Product Change Notification

1. **ECR #:** 209301
Notification #: 615

2. **Date of Announcement:** November 18, 2021

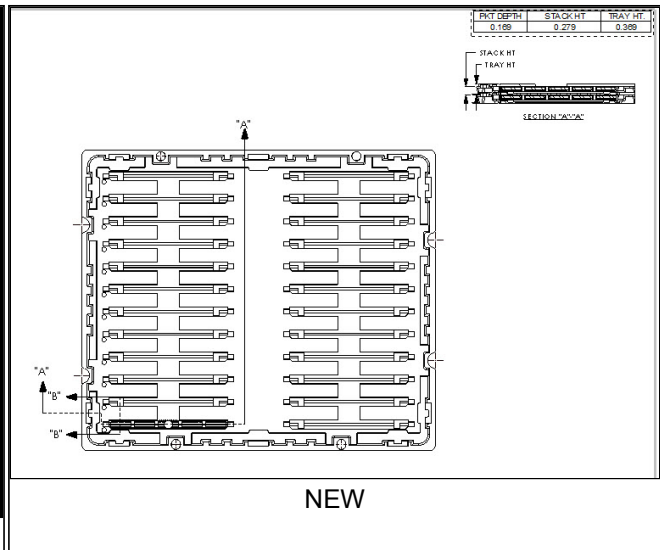
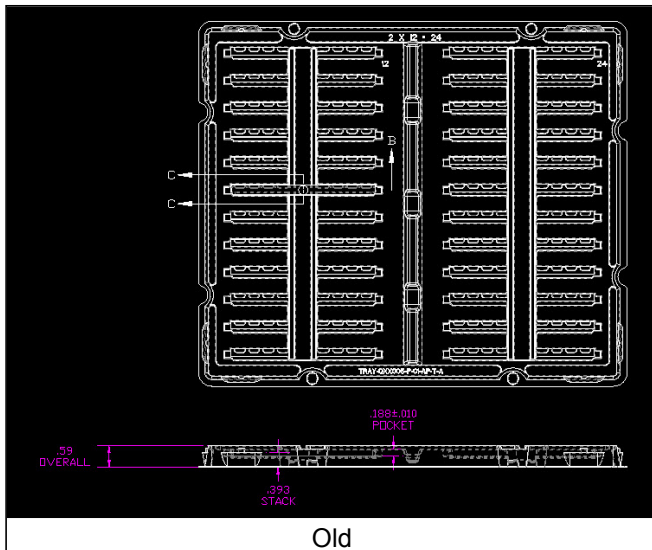
Update current tray to the new standard, pocket depth, tray height, and stack height has been modified.

Pocket depth change from 0.188" to 0.169", tray height change from 0.590" to 0.369", stack height change from 0.393" to 0.279".

Due to an engineering review process, this tray was selected to get an update to the latest standard to improve the pocket design to keep parts inside and more stable.
